WAKE COUNTY N.C. P.D.I.

THE
ONYX 2023 -A
LOT 60 MCLAURIN FARM

FIRST FLOOR PLAN

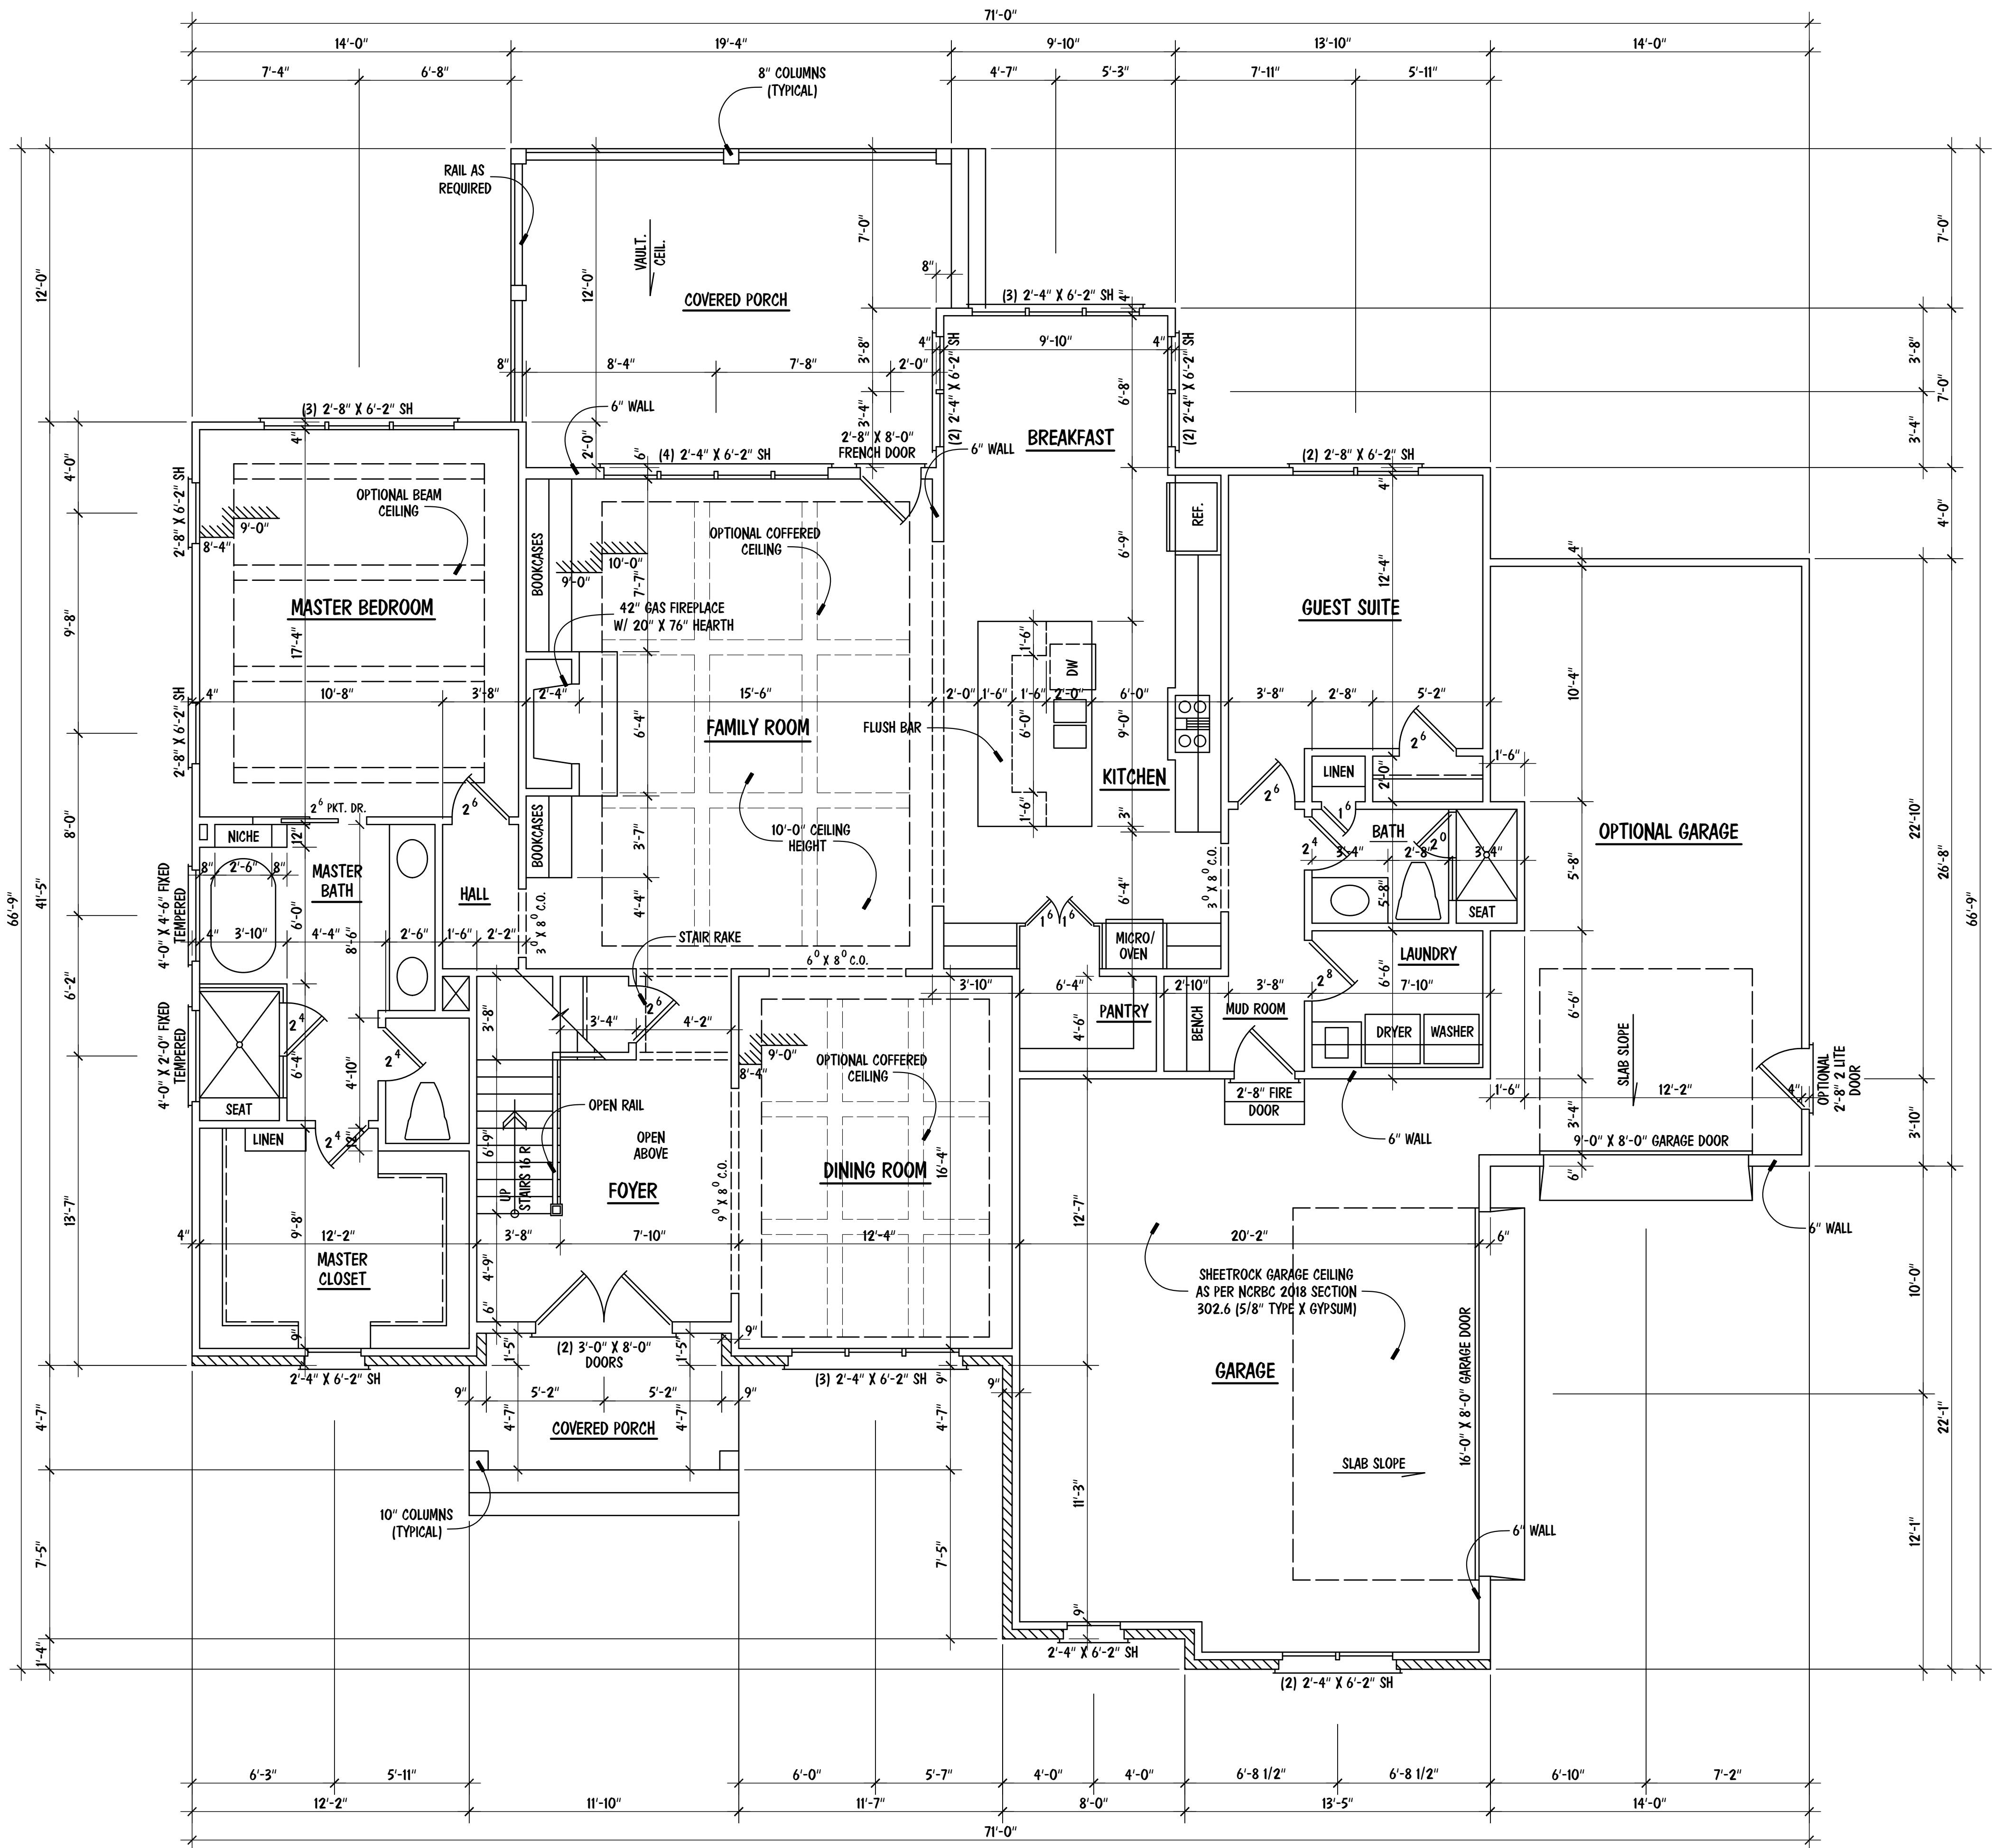
Garages are required to be fire separated from habitable areas per section R302.6 of the 2018 NCRC.
